Junee Subdivision

Road Safety Audit

RES2305.40.115-RSA

Date: 2/09/2023

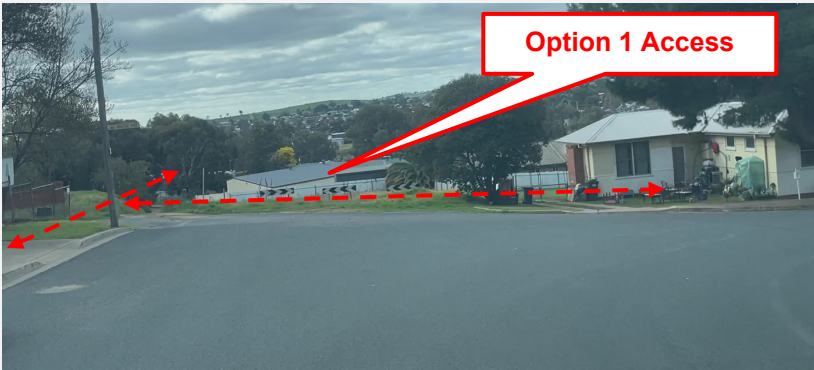
GE	General Observations	Photos / Reference
GE-1	<p>The southern extent of the existing school zone is located north of the Vaughan Street/Gallipoli Ave intersection with Kitchener Street. This does not cover the “School Drop-off Pick-up ZONE” located west of this intersection on Vaughan Street.</p> <p>School children were observed walking south along Kitchener Street towards Endeavor Park area (Pretoria Street).</p> <p>It is unclear why the extent of the school zone does not include the “School Drop-off Pick-up ZONE” located west of this intersection on Vaughan Street.</p>	 <p>Looking north on Kitchener Street toward the existing school zone.</p>  <p>Extract: Ason Group Traffic Impact Statement.</p>

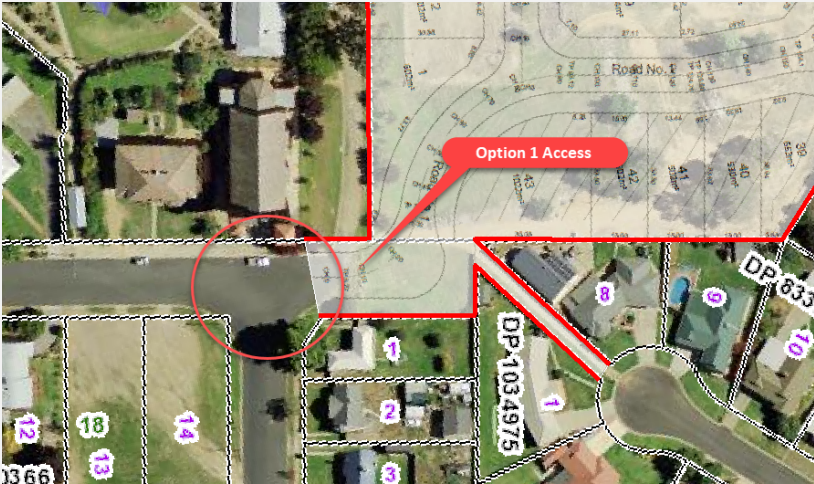
GE	General Observations	Photos / Reference
GE-2	<p>At the time of the PM site inspection, it was observed that the “School Drop-off Pick-up ZONE” did not appear to be in use by parents or staffed by school monitors.</p> <p>It appeared that the area in front of Saint Jospeh’s Catholic Church (north of the bus zone) or the opposing side of Kitchener Street was instead being used by parents picking up children.</p> <p>Considering the availability of the infrastructure on Vaughan Street, this resulted in an undesirable mix of children pick-up and bus stop operations.</p>	 <p><i>Looking east in the “Drop-off Pick-up ZONE”</i></p>  <p><i>Looking north toward bus stop on Kitchener St.</i></p>
GE-3	<p>At the time of the PM site inspection, a “Walking School Bus” was observed crossing Anzac Ave at the end of Kitchener Street (Option 1 access location), walking children on the northern side of Anzac Ave as far as the northwest corner of Anzac Ave and John Potts Drive intersection (Yellow). Additionally, at the time of the PM site inspection, several children were observed continuing from Anzac Ave at the end of Kitchener Street (Option 1 access location), onto the gravel access track toward the alleyway connecting to Pike Place (Red).</p> <p>It should be noted that Option 2 access (via John Potts Drive) may adversely impact the current access to the Pike Place alleyway, where as Option 1 access (via Anzac Ave/Kitchener Street) presents the opportunity to formalise an all weather access to the Pike Place alleyway.</p>	 <p><i>Overview of prominent pedestrian movements.</i></p>

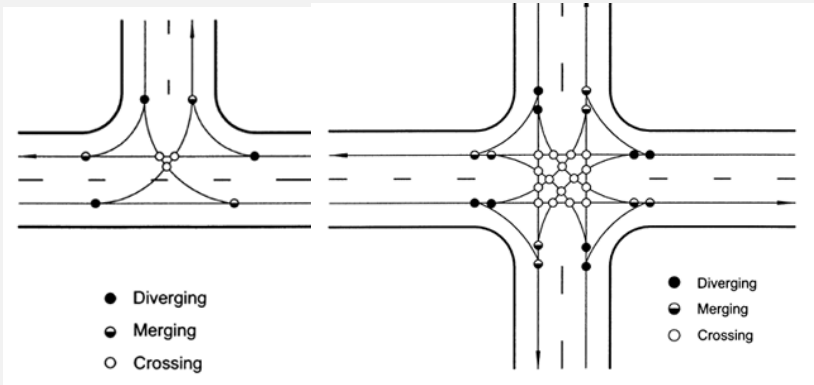
GE	General Observations	Photos / Reference
GE-5	<p>There is existing lighting and stormwater infrastructure that would require adjustment at the Option 2 access location (14 John Potts Drive).</p> <p>The existing light post is located in the middle of the vacant block where the proposed development access will be located joining John Potts Drive.</p> <p>The existing stormwater pit is located in the middle of the vacant block where the proposed development access will be located joining John Potts Drive.</p>	 <p><i>Looking southwest toward Option 2 access.</i></p>  <p><i>Looking south toward Option 2 access.</i></p>
GE-6	<p>It is acknowledged that the provision of artificial lighting will form part of the development requirements. Consideration needs to be given to the adequacy of the existing lighting at the development access location adopted.</p>	 <p><i>Looking north down Kitchener Street at the proposed development intersection.</i></p>
